# Access Compliance Report

| Intersection ID: 27907                  | Main Street: BAY_HILL_CLUB_DR | Cross Street: COLONIAL_COUNTRY_LN       | Location: S            |
| ADA ID: B8E057954404                    | Ramp Type: Perp               | Initial Pass/Fail: Fail                 | Overall Compliance: No |

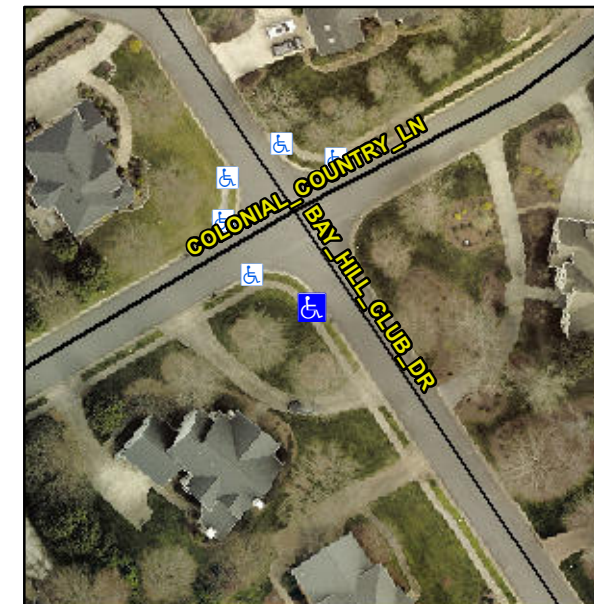
**Not Found, R304.2.2**

| Compliance | Description           | Data  | Compliance | Description                 | Data |
|------------|-----------------------|-------|------------|-----------------------------|------|
| N/A        | Ramp Length (in)      | 50.0  | No         | Ramp Slope (%)              | 12.5 |

**Remove & Replace Entire Ramp.**
